# Purpose of Change

#### Re: Application for a Permissive Change Filing with FCC ID: VLJ80-8160-01 IC: 4522A-80816001

The purpose of this document is to describe all the changes that are made on **BASE Unit** to the new designed family models **L70XM** from the original model **L70X** in order to meet the requirements.

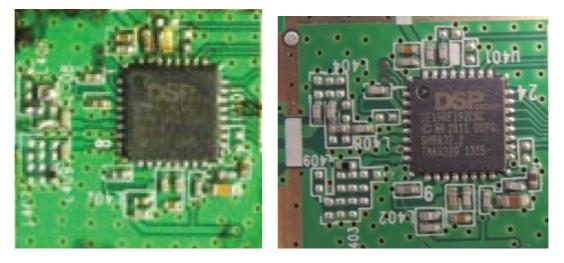
- The model no. of RF IC changed to DE19RF19ZCNC from DE19RF19ZANC
- The ratings of some RF components are changed (Add: C409 & C401:15pF / C419 & C406 from 2pF to NC / C423 from NC to 47R): and L404 & L403 location is rotated/minor changed on RF PCB,
- The Base change for meet CEC requirement.
  1. UG2 change to BL8022 from BL1117
  2. Add D5,C81,C93,C96,R70,L13,R11,R14,C110,C114
  3. Delete DG6,CG107

The Base change to use Adaptor (TenPao: S003IU0600040) for meet CEC requirement.

• Charger Part is added current Limited circuit for meet CEC requirement.
